"HIGHLAND ESTATES, LOT 9"  
2185 COBBLEHILL PLACE  
SAN MATEO COUNTY, CALIFORNIA  
THE CHAMBERLAIN GROUP  
655 SKY WAY, SUITE 230  
SAN CLEMENTE, CALIFORNIA 94076  
PHONE (951) 365-5582 FAX (951) 365-5666

Subject: Highland Estates, Lots 9-11, San Mateo  
BKF Response to County Planning Department Setback Comments

Re: Planning Comments on Lots 9-11

From: Camille Leung, Senior Planner

# Lot 9 Approved Plan

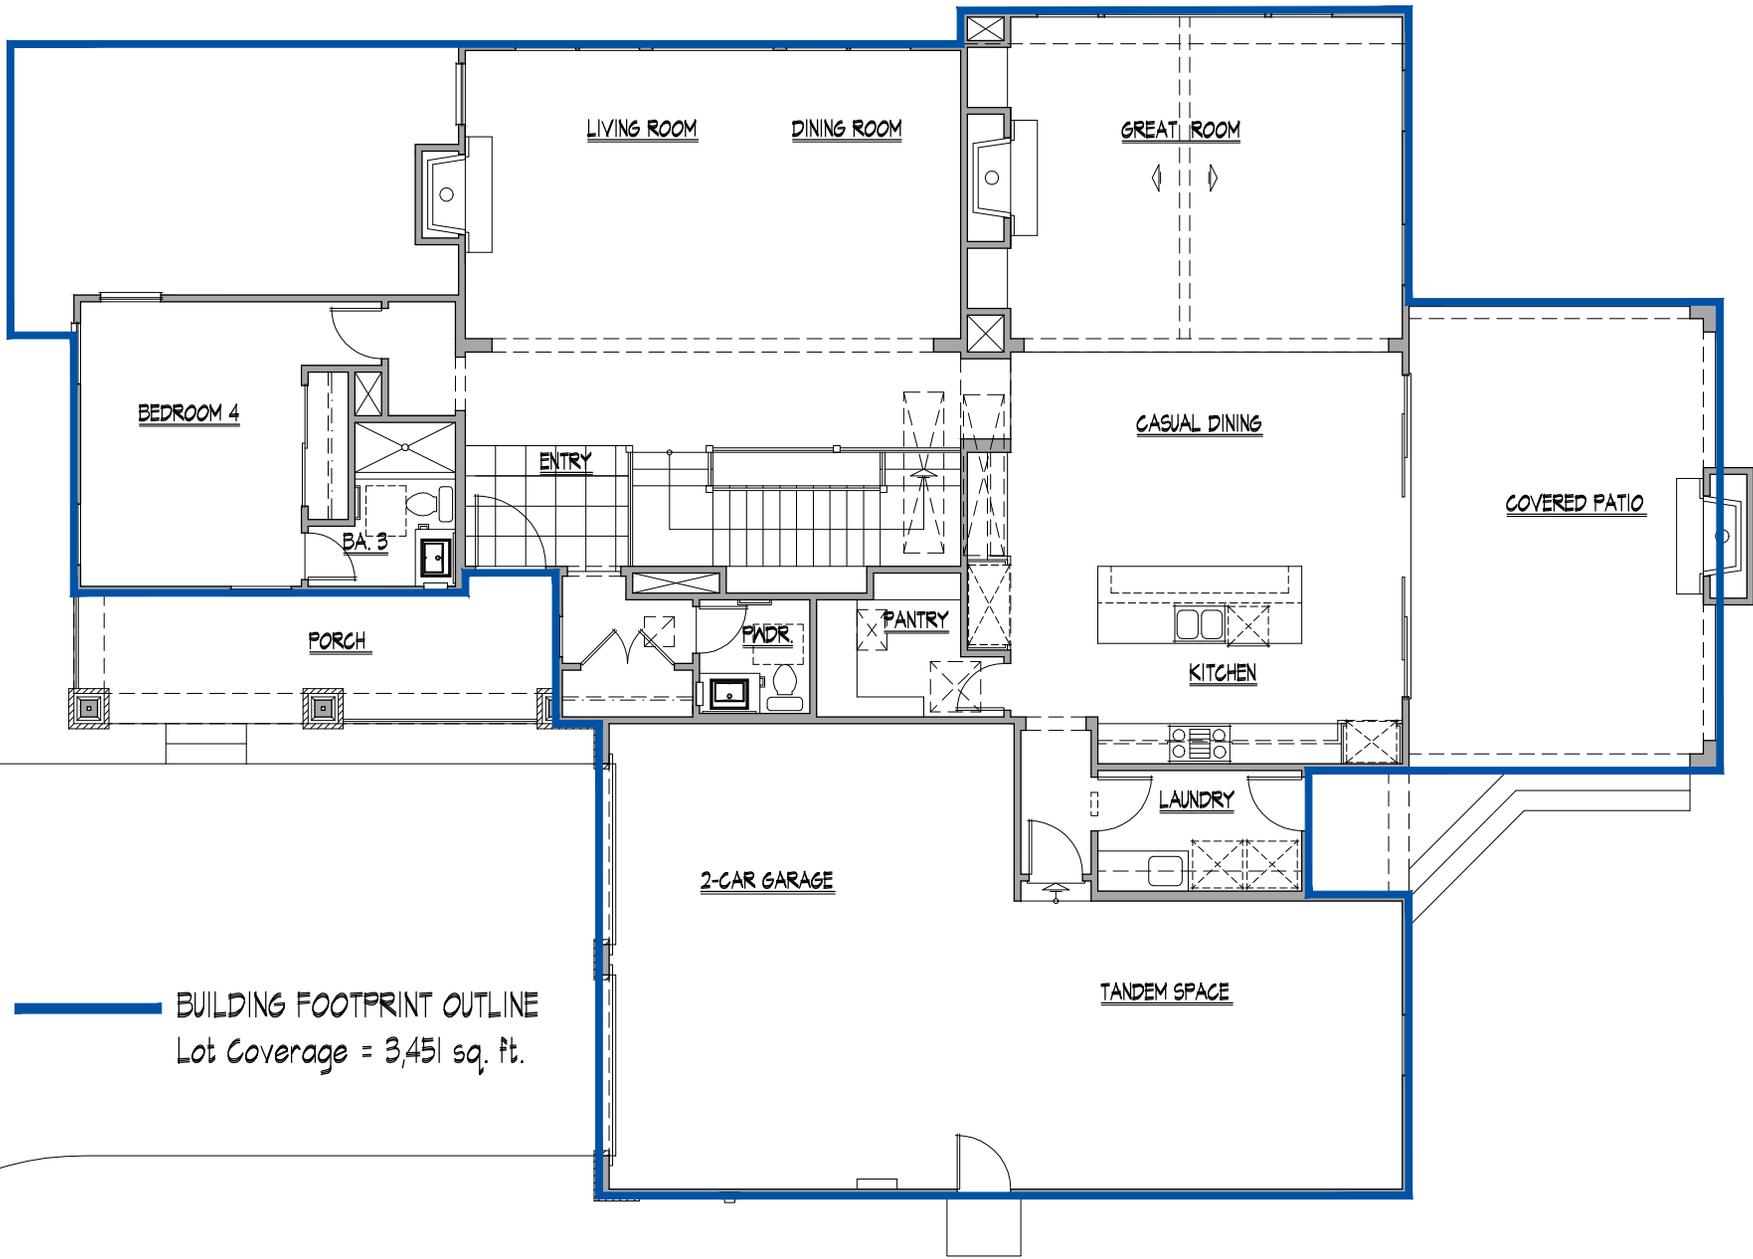
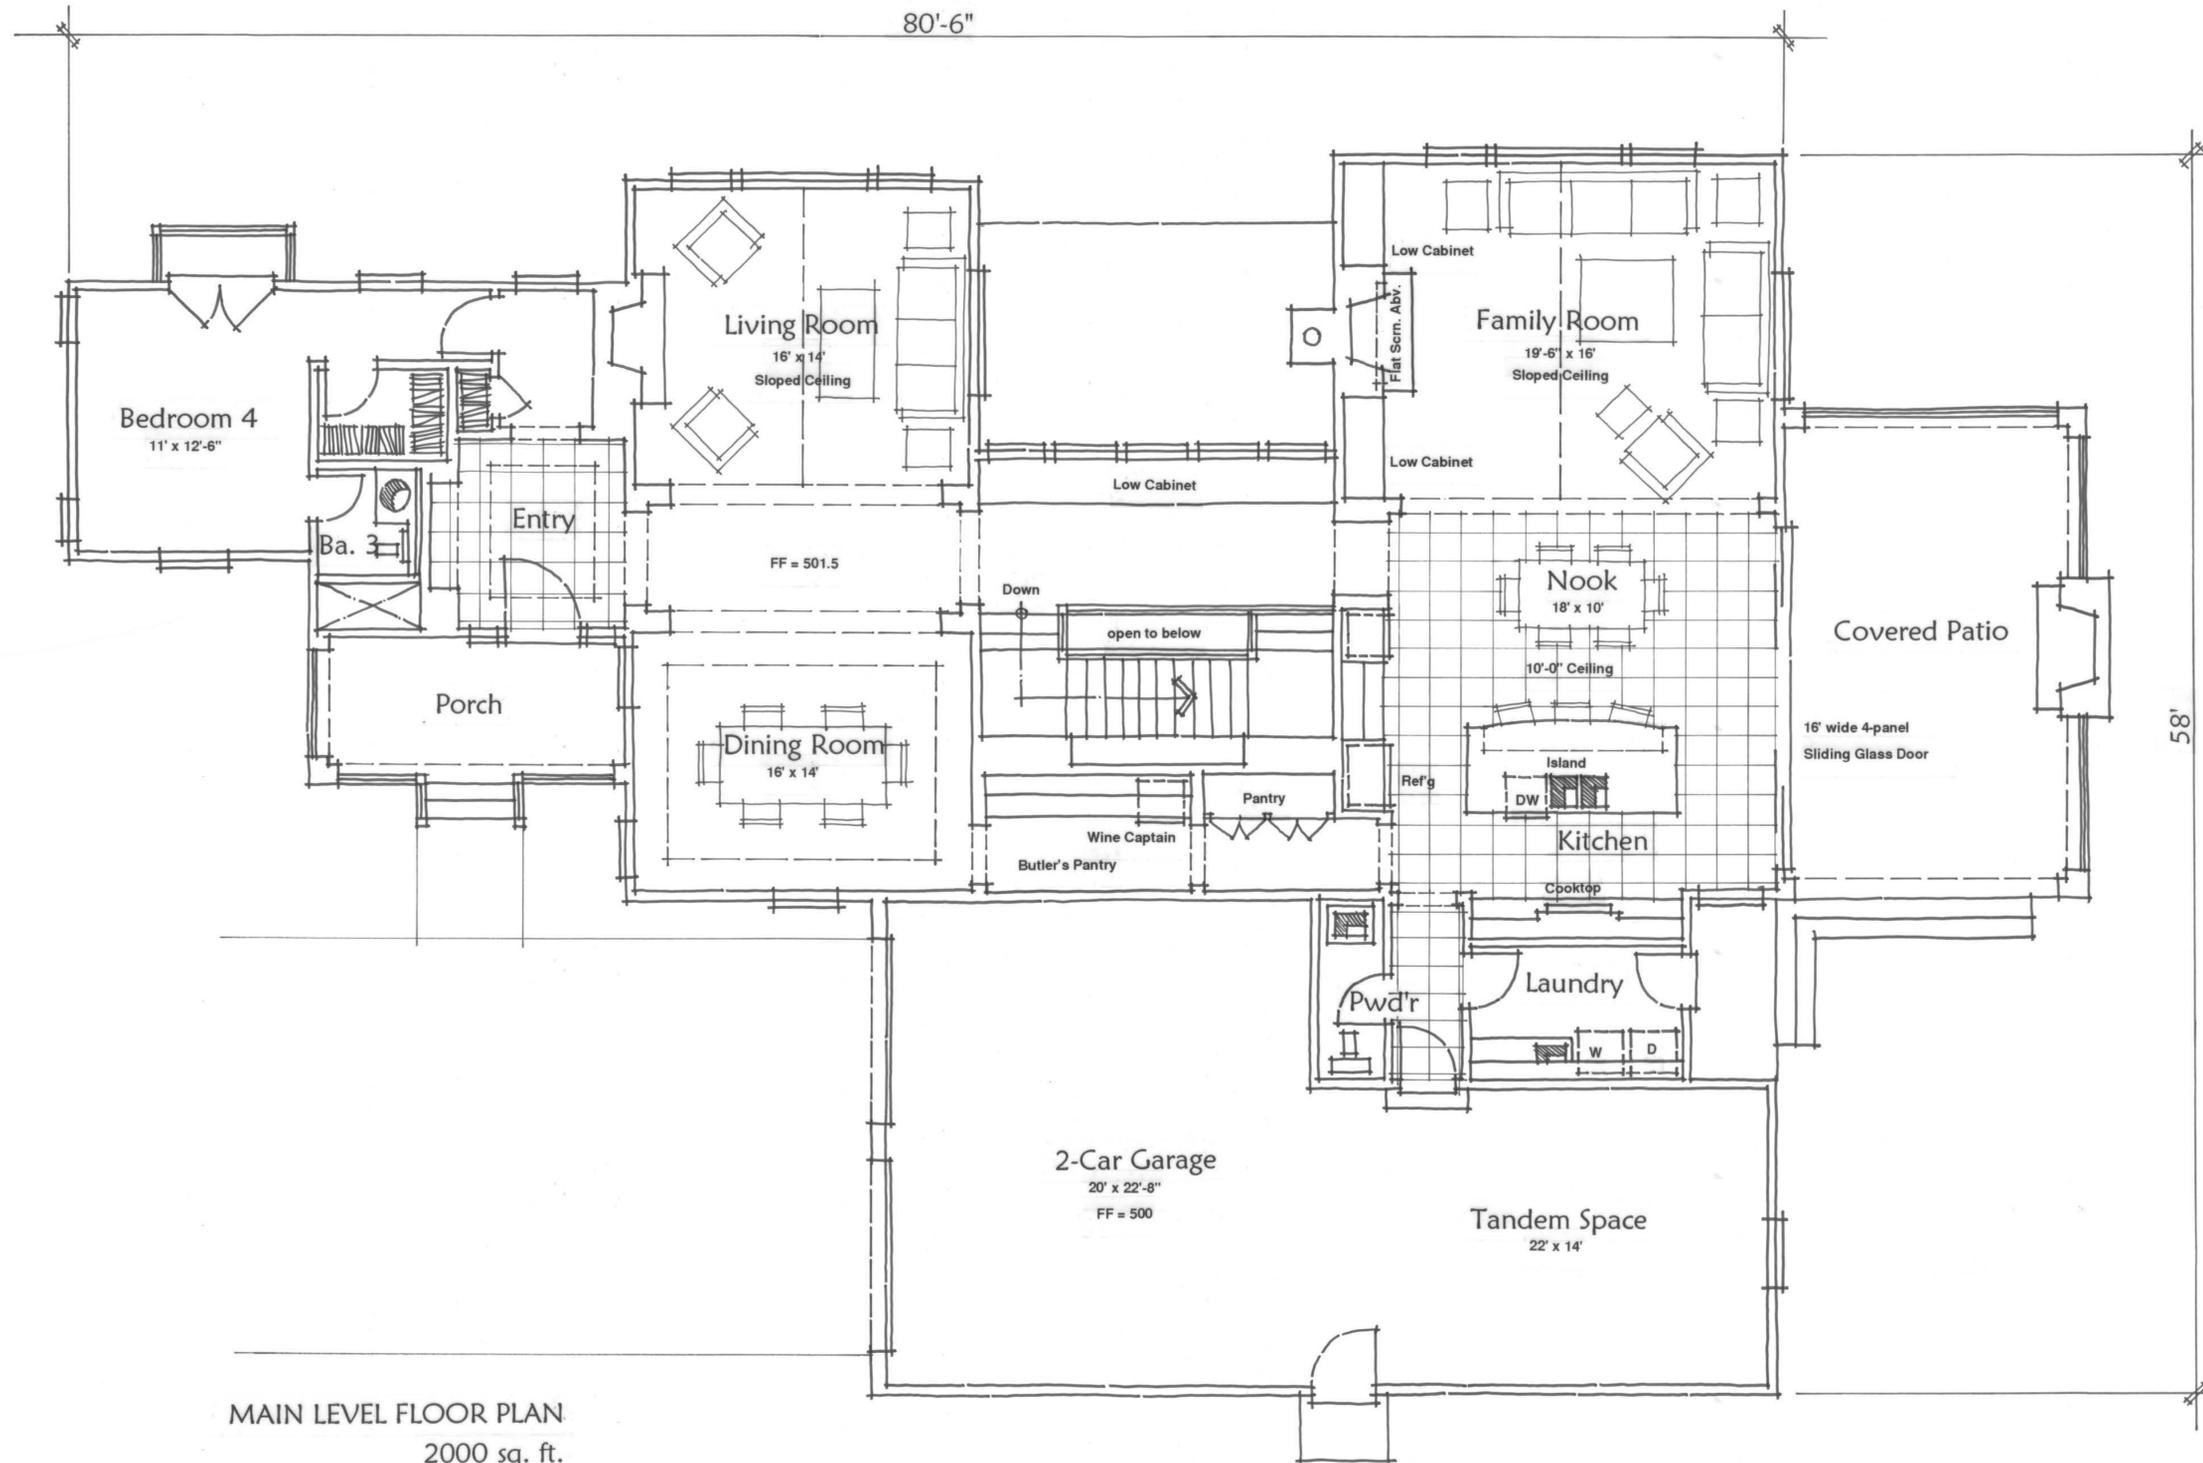
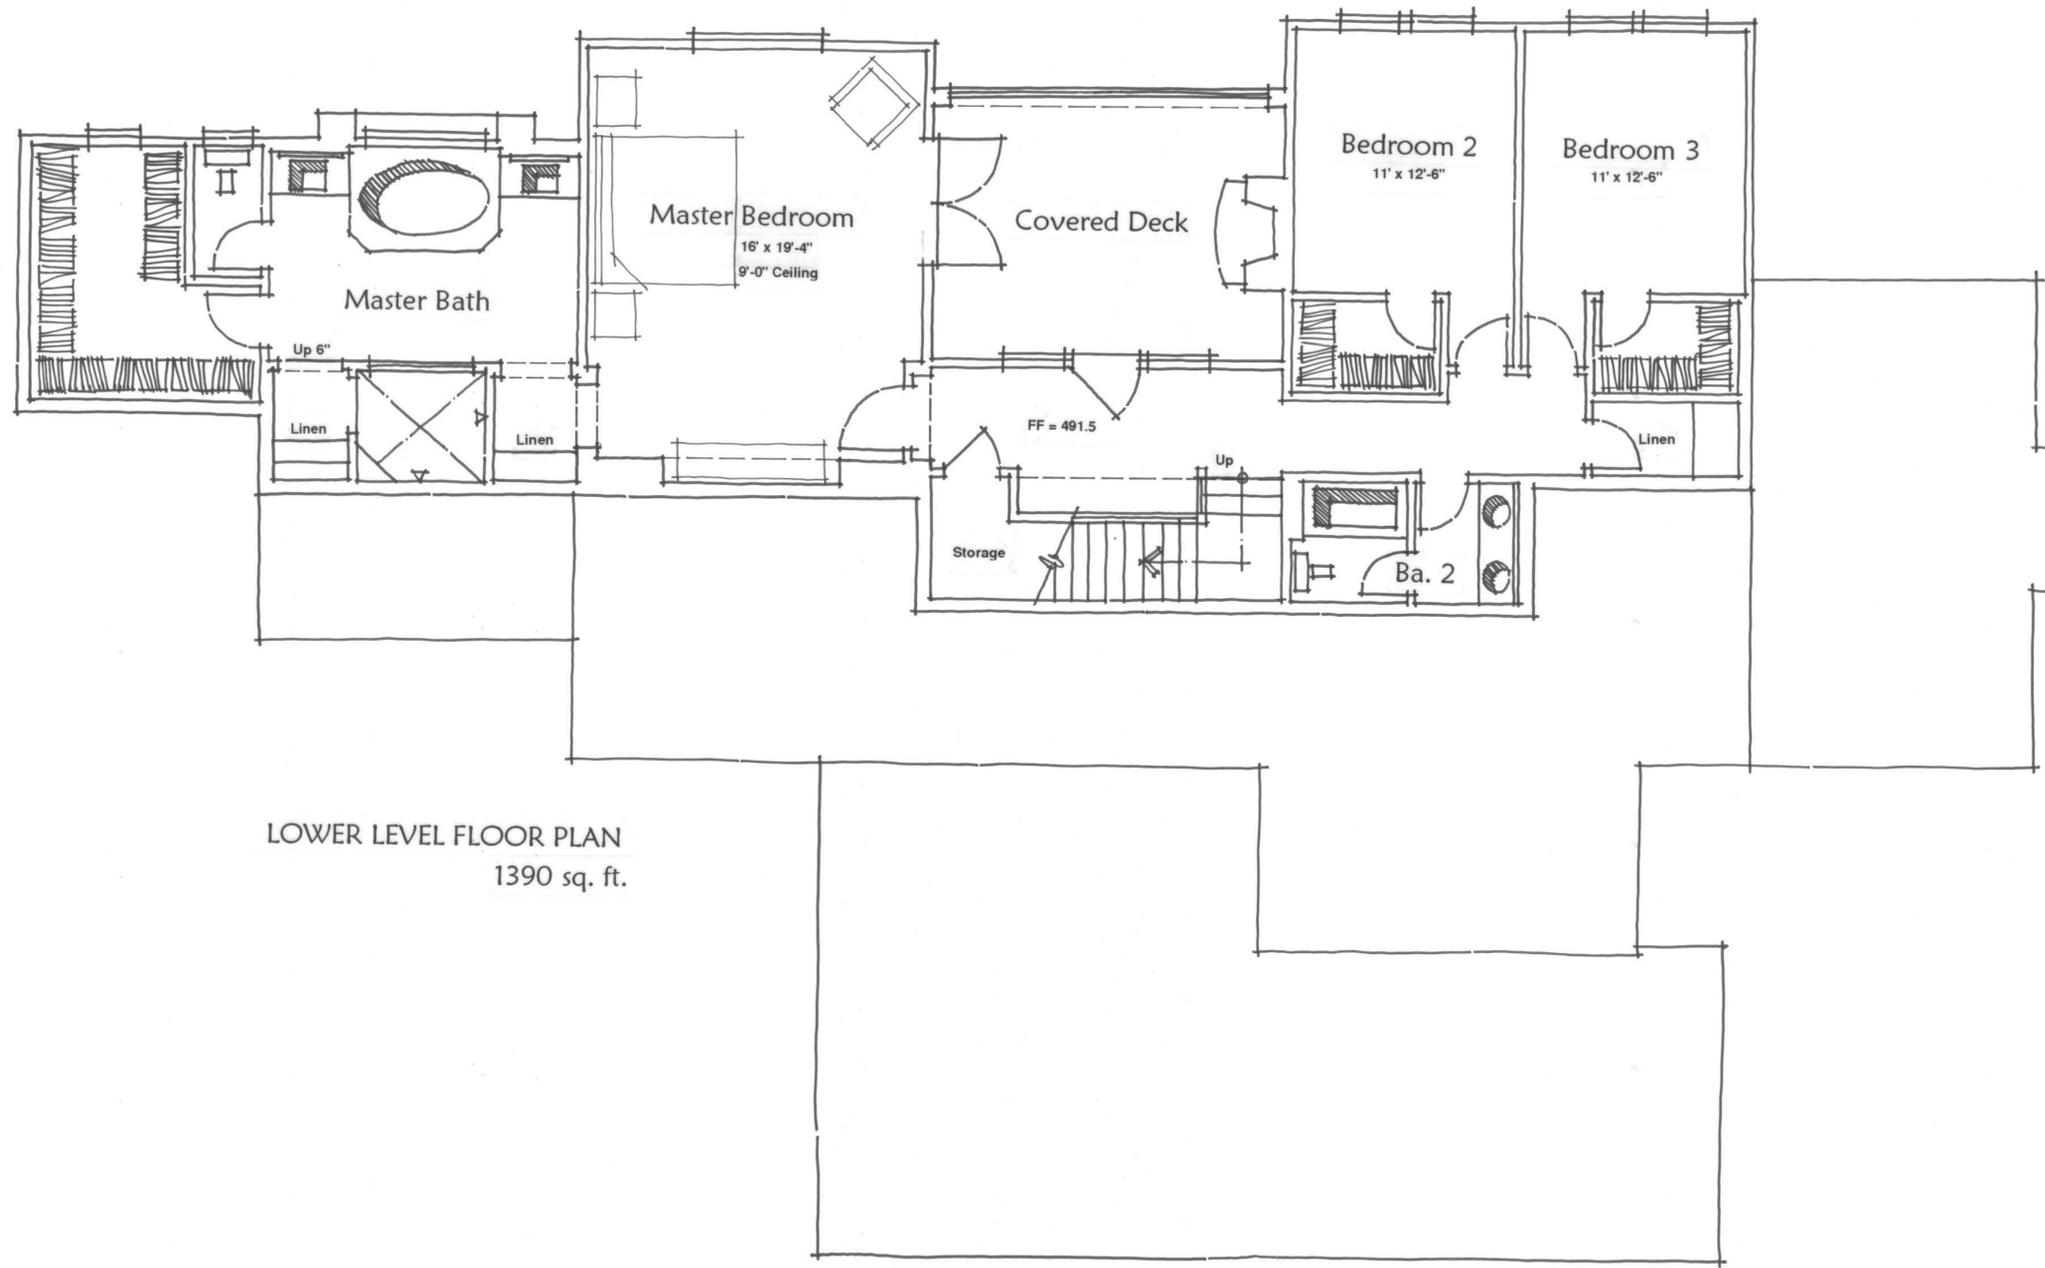
Applicant has consolidated the building footprint. County has requested calculation of approved and proposed footprint areas.
